**SR-2 – STAFF ADVISORY REPORT (09-08-2026) (REVISED 09-08)**

**ADDRESS:** 15067 WARWICK

**APPLICATION NUMBER:** HDC2026-00289

**SCOPE:** DEMOLISH GARAGE, ERECT GARAGE

### Staff comments on proposed garage

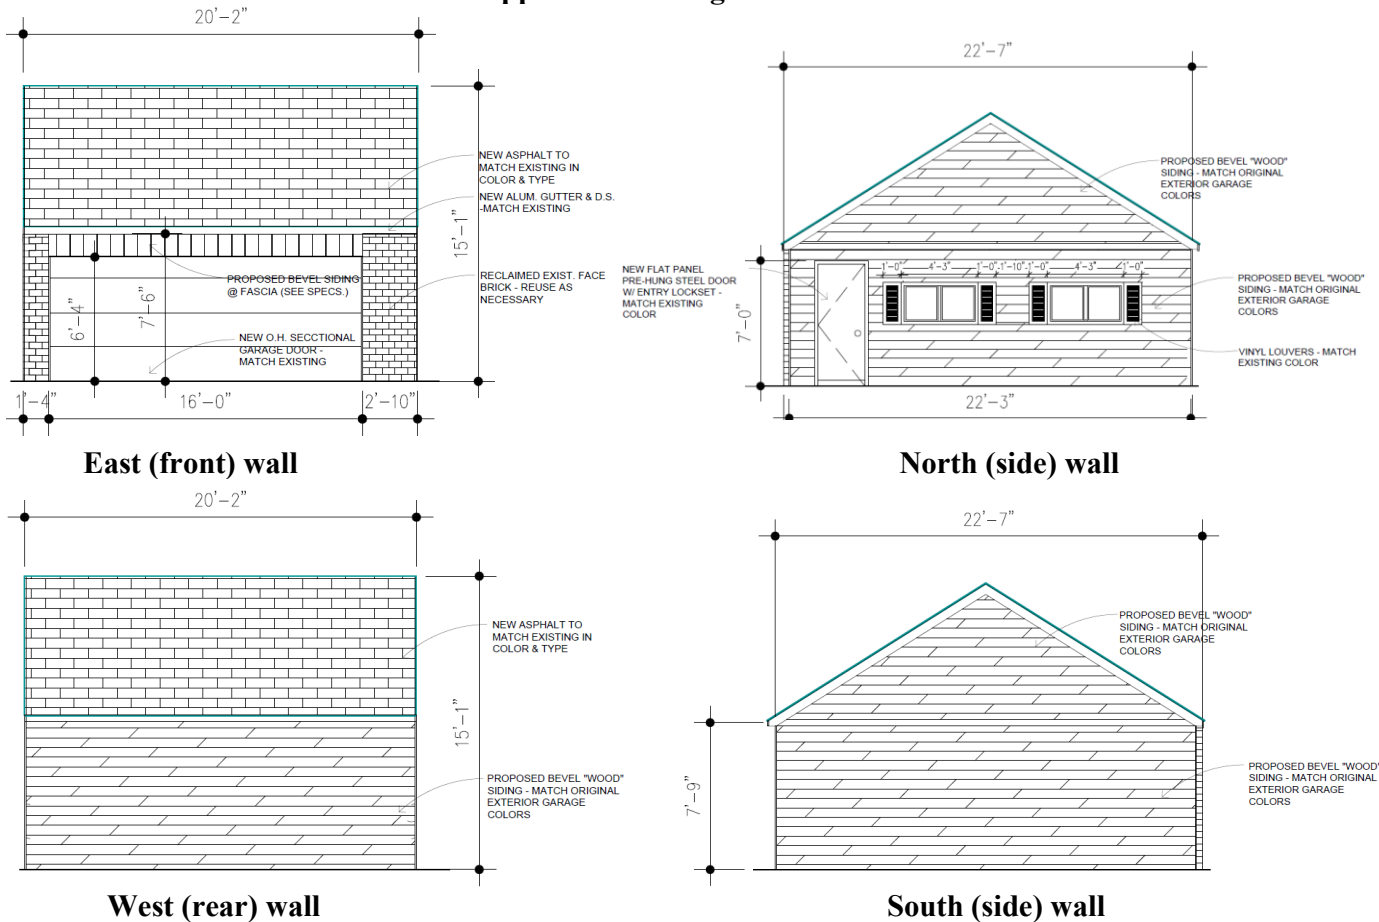
- The proposed garage's massing, roof design, window and door placement and brick cladding on front walls flanking the overhead door opening closely matches the existing garage.
- The proposed dimensions are: 20'-2" wide x 22'-7" deep x 15'-1" high. This is slightly larger than the existing garage, which the applicant states is 18' wide x 21' deep.
- ~~The submitted site plan shows the footprint of the existing garage. Although the new garage will be erected in the same location, it will be slightly larger (which needs to be documented) and the setbacks from the side and rear property lines must be noted.~~

- It is staff's opinion that the dimensions, massing, and overall design of proposed garage offers a compatible design for this property.
- However, there are discrepancies between the drawings and the selected materials and building components.

- The dimensions listed for the east and west walls on the garage floor plan on Page A101 do not match the elevation drawings, site plan, nor the overhead door cut sheet.

- The proposed windows on the north wall are Anderson 400 series vinyl aluminum-clad sliding windows. Sliding windows are a mid-20<sup>th</sup> century product and the horizontal uneven sash depths is not compatible with the property. Casement windows, or double-hung windows offer operability for ventilation while conforming to the traditional proportions, operation and sash placement of the dominant windows within the historic district. The exterior cladding color is not noted. The submitted cut sheet shows a grille pattern, however the drawings show undivided glass. The double-hung windows on the house have a distinctive pattern of 15-over-1, with lead caming. As the garage is new construction and a secondary structure, it is staff's opinion the garage windows should have undivided glass so there is no visual conflict with the complex divided light patterns of the house windows.

- ~~The drawings show the shutters to be exceptionally short, bearing no relationship to the window openings.~~ The shutters on the north elevation drawing have been redrawn to extend the height of the windows, however, the submitted previously submitted cut sheet lists a dimension of 14-1/2" w x 47"h. Staff scaled the height of the windows to be approximately 2'-6"h, and the listed width is 12". The current suggested material is vinyl. The shutters are proposed only for the north wall of the garage which is not visible from the public right-of-way. Rarely has staff seen shutters installed adjacent to garage window openings. There is no requirement for the new garage to match this design feature of the existing garage. Should the Commission consider approving the shutters, a new cut sheet for the correct shutter size should be submitted to staff for review.

- The wall section on Page A101 note that gutters and downspouts will be installed, but the

- Not all colors are noted, and those that are, are either generically identified (ex., new wood siding “to match original garage colors”), or a non-compatible color is suggested (ex., white for the overhead door). A compatible color scheme for the new garage is to match the comprehensive dark brown palette of the house, thus removing white and/or black colors from the current proposal.

1. ~~The site plan garage floor plan on Page A101 will be corrected to show the accurate east and west wall dimensions as listed on the elevation drawings and site plan and property line setbacks.~~
2. ~~Wood or cementitious lap siding is selected for the garage walls, with exception of the areas already proposed for masonry cladding.~~
3. Aluminum-clad wood windows are selected, with casement, double-hung or single-hung operation. Undivided glass will be selected.
4. ~~The drawings will be revised to accurately reflect door and window openings and exterior~~

5. Cut sheets for all products will correlate with the revised drawings. Finish colors will be noted on the drawings or within the cut sheets. ~~The color palette will be dark brown, matching the color palette of the house. Paint colors submitted for review must include manufacturer name, paint name, paint number, as well as a visual sample.~~
6. The revised drawings and cut sheets will be submitted to staff for review.
